RESTRICTIVE COVENANT AMENDMENT REVIEW SHEET

CASE: C14-91-0015(RCA)
Champion Commercial Development

Date: March 11, 2011
To: Clark Patterson, Case Manager
CC: Kathy Hornaday, P.E., PTOE
HDR Engineering, Inc.
Reference: Champion Commercial Development, C14-91-0015(RCA)

Exhibit A: Roadway Exhibit

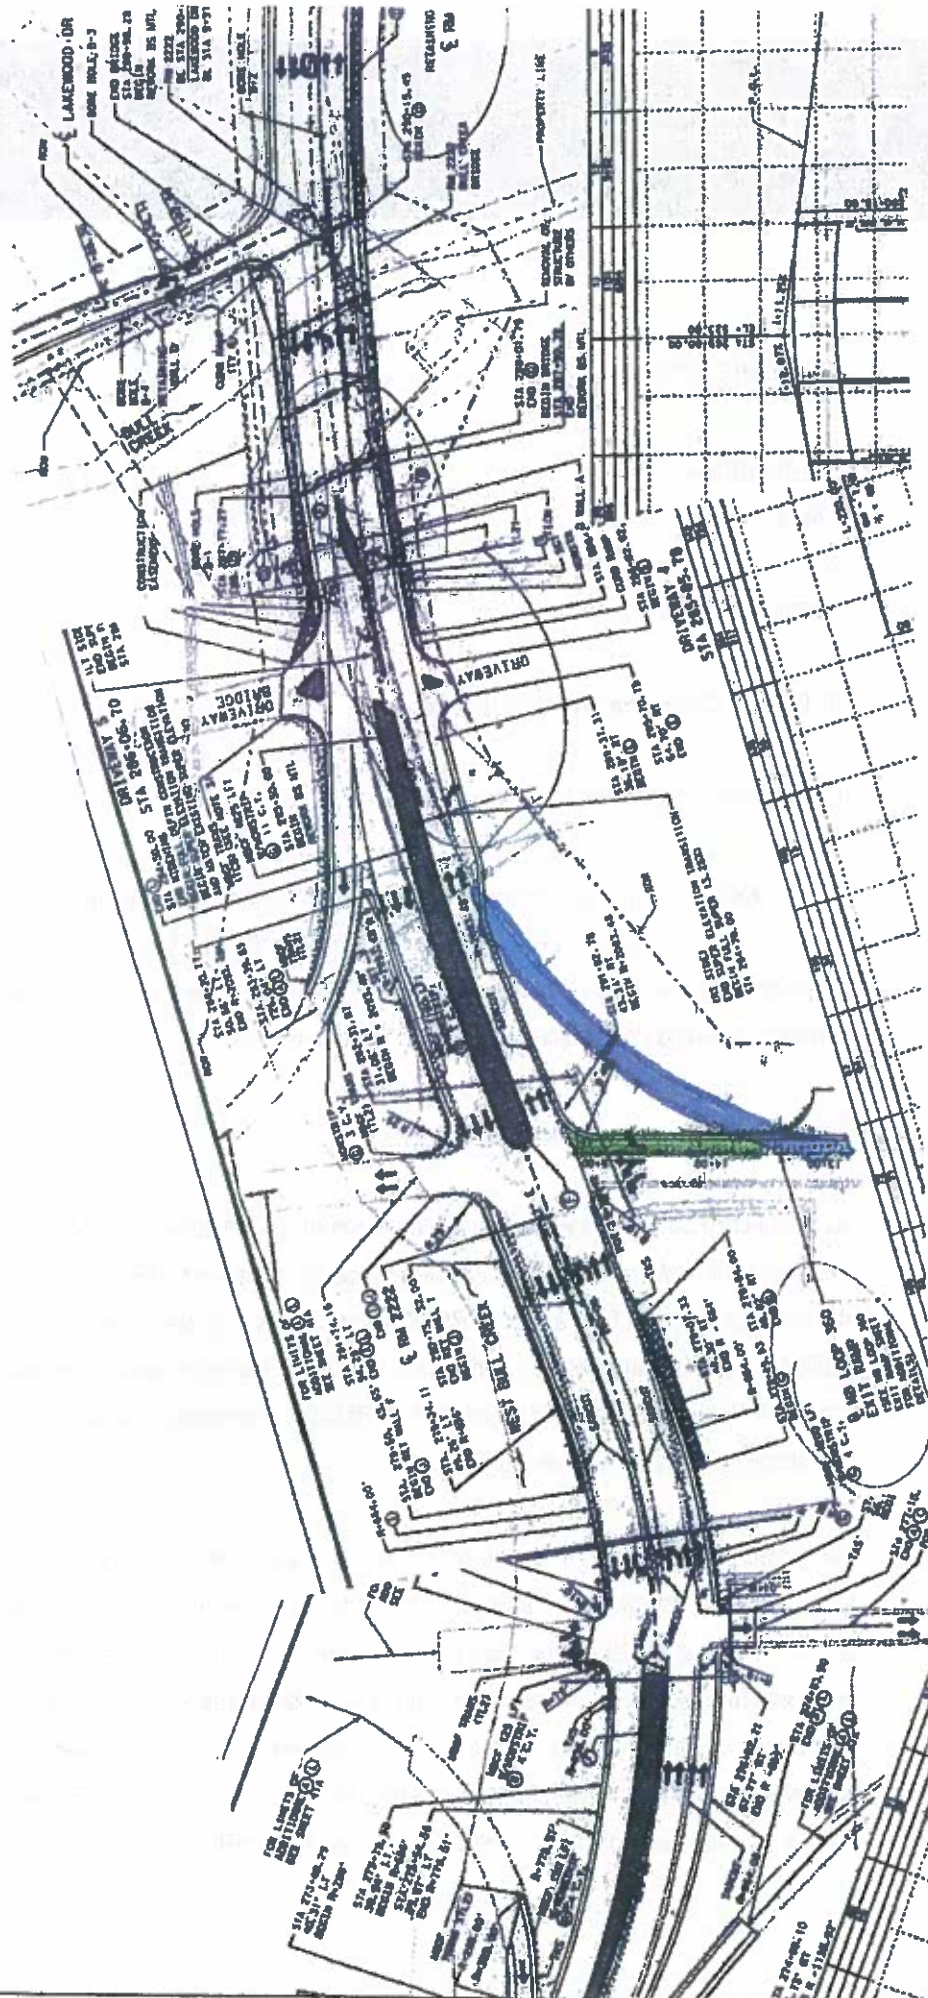
The Texas Department of Transportation (TXDOT) is currently reconstructing RM 2222. The reconstruction project includes widening of RM 2222, a left-turn lane for eastbound traffic turning onto Lakewood Drive, and removal of the dedicated right-turn lane from northbound Capital of Texas Highway to eastbound RM 2222. A signal will also be installed at Lakewood Drive and RM 2222. The widening of RM 2222 will provide sufficient width to accommodate a left turn lane into this site from RM 2222 (See Exhibit A – Roadway Exhibit).

Two scenarios were analyzed. The first scenario assumed the conditions of the existing restrictive covenant, which is, only right-in, right-out access is allowed on RM 2222. In scenario one, traffic from westbound RM 2222 have two options to enter the site:

The second scenario assumed the conditions of this request for restrictive covenant amendment. In scenario two, a left turn bay provides left-turn access into the site for traffic from westbound RM 2222.

- 1) Left-turn access into the site from westbound RM 2222 is recommended for this site. Roadway and driveway improvements should be provided in accordance with the assumptions in the TIA update.

Figure 1
RM 2222 Proposed Lane Configuration

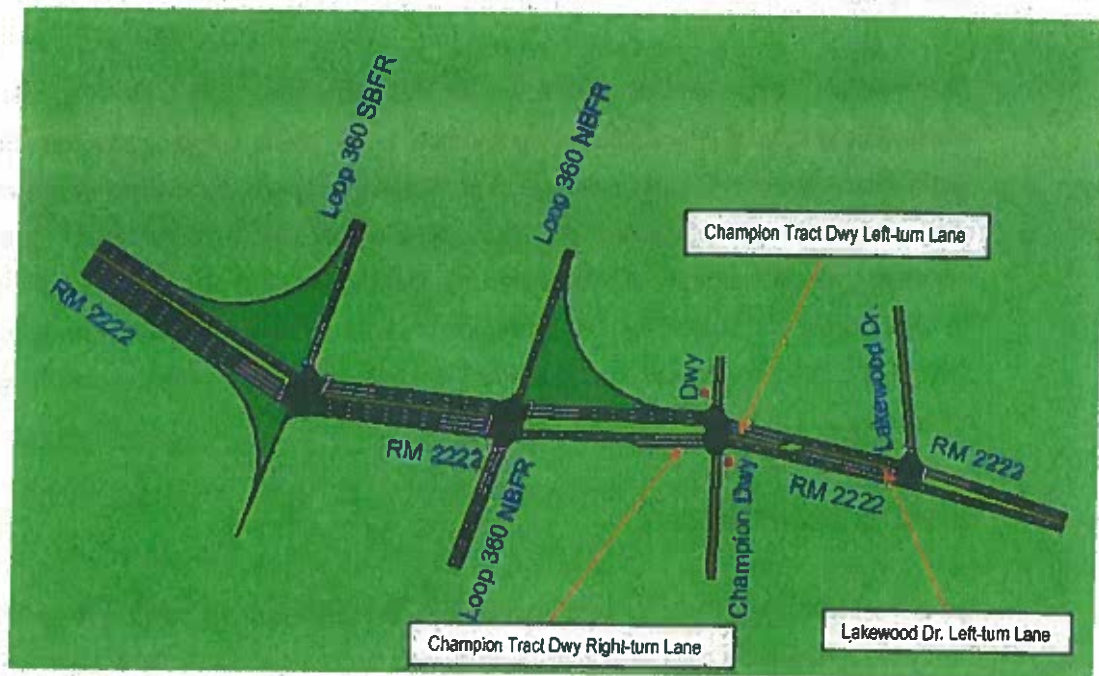
At present, the driveway is approved as a right-in/right-out only driveway. TxDOT is currently reconstructing this section of RM 2222, which will result in available pavement width to provide a left-turn lane for this driveway, as shown in Figure 1. The RM 2222 project also includes providing a left-turn lane for eastbound traffic turning left onto Lakewood Drive, and it removes the large-radius northbound right-turn lane at the Loop 360 Northbound Frontage Road (NBFR)/RM 2222 intersection. A signal will also be installed at the intersection of Lakewood Drive and RM 2222.

As shown in Figure 1, the Champion Tract driveway on RM 2222 will be aligned with an existing driveway to a retail center on the north side of RM 2222. This driveway is a right-in/right-out only driveway. Counts were not available for this location; therefore, traffic to and from this retail center was estimated given the land use present on the site, which includes 14,600 square feet of quality restaurant, 8,330 square feet of high turnover restaurant, and 4,070 square feet of shopping center. (Trip generation information is enclosed.) The retail center also has an access driveway (not depicted) on Loop 360 Northbound Frontage

Given the results of this analysis, I respectfully request that a westbound left-turn lane on RM 2222 be approved for construction to allow "left-turn in" access to the Champion Tract site. Please feel free to contact me if you have any questions regarding this information.
